Sunset Arts & Advertising Subcommittee Briefing Memo Current and Historic Preservation Planning

8222 Sunset Boulevard

Sunset Arts & Advertising

Proposed Billboard Application: The purpose of this meeting is to give initial feedback on design aspects of the proposed billboard structure at this location. This includes two-sided, billboard with 1,000sf of full-motion animated billboard facing east and 480sf of an eight second ad rotating billboard facing west. There is currently no billboard on this site.

Original Concept Award Design

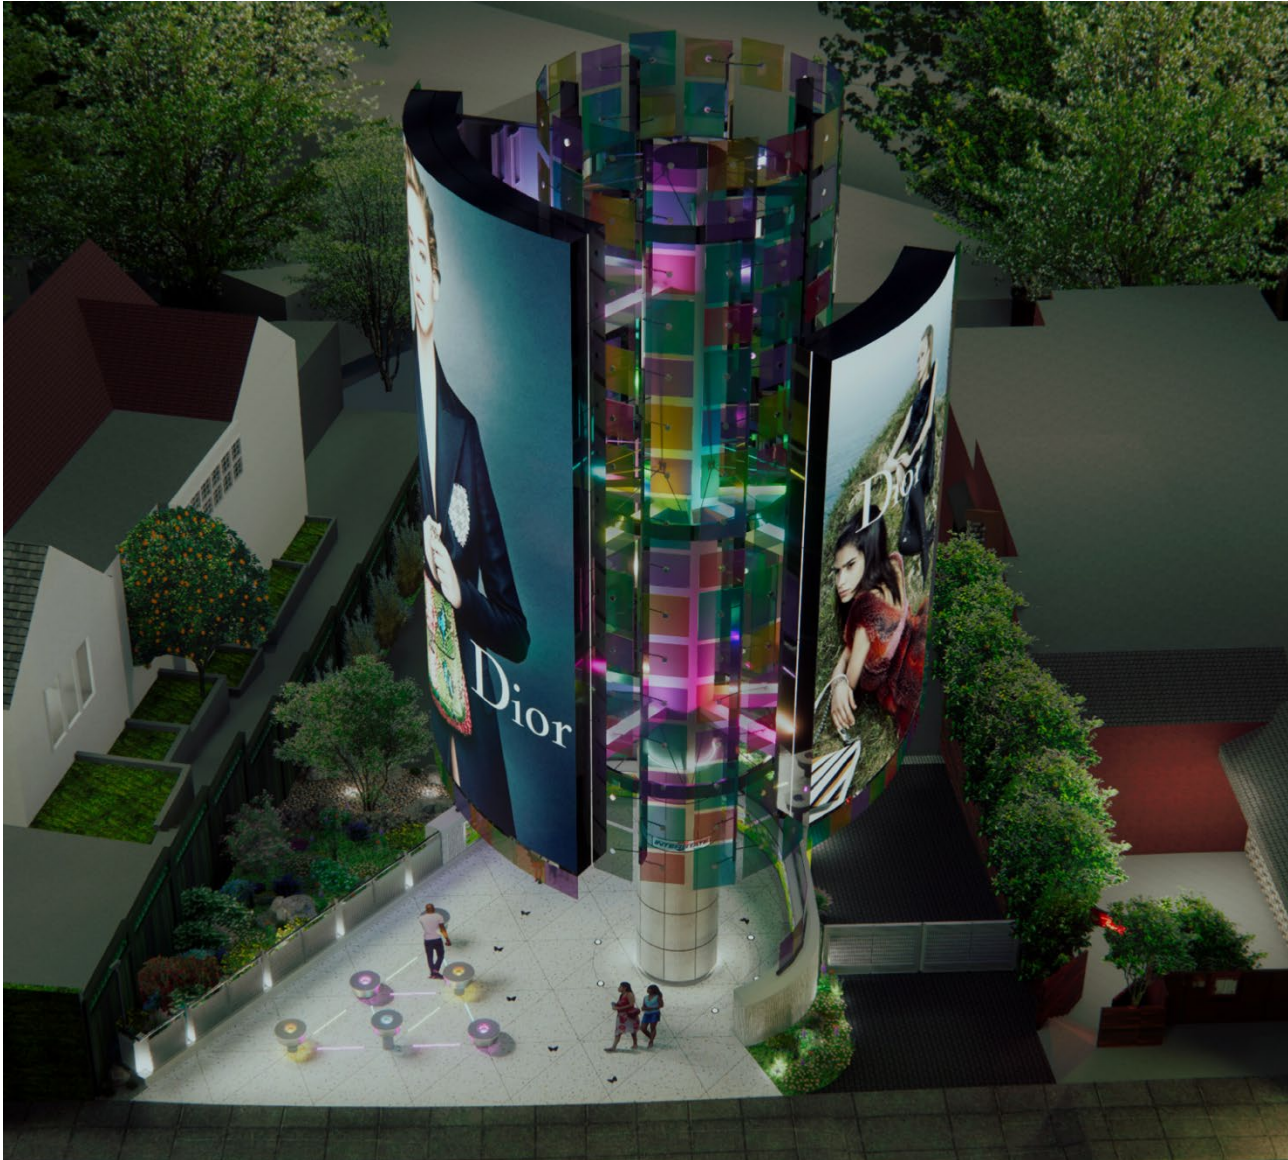
The project consists of a new, two-sided billboard just east of The Den restaurant and bar at 8222 Sunset Boulevard. There are four separate parcels at this location, two of which are located within Los Angeles and two in West Hollywood. The proposed billboard project will be solely located in the parcel at 8222 W Sunset (APN 5554-018-022). The original proposal, shown below, required significant revision to meet the design standards of the billboard policy, to fit within a window where existing billboard to the east and west were not obstructed, and to provide a more interactive pedestrian space.
